Application No.: 10/724,191
Amendment dated: 12/30/05
Reply to Office Action of 9/14/05

Amendments to the Drawings:

REMARKS

FIG. 7

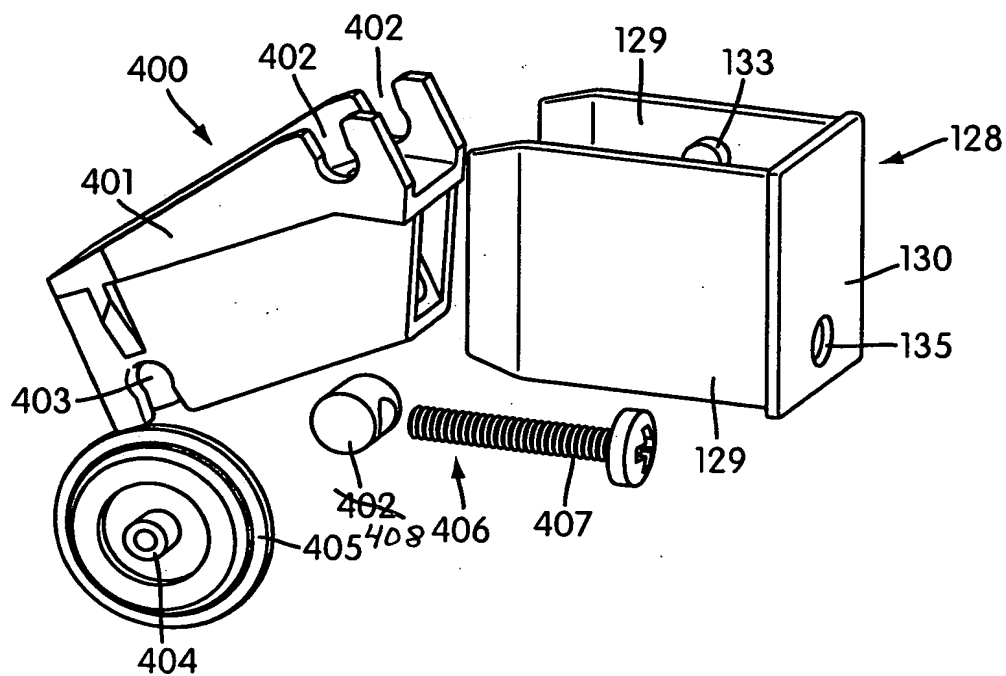
In Figure 7, the nut 402 has been changed to "408".

Figure 7 has been amended to identify the nut by the numeral 408.
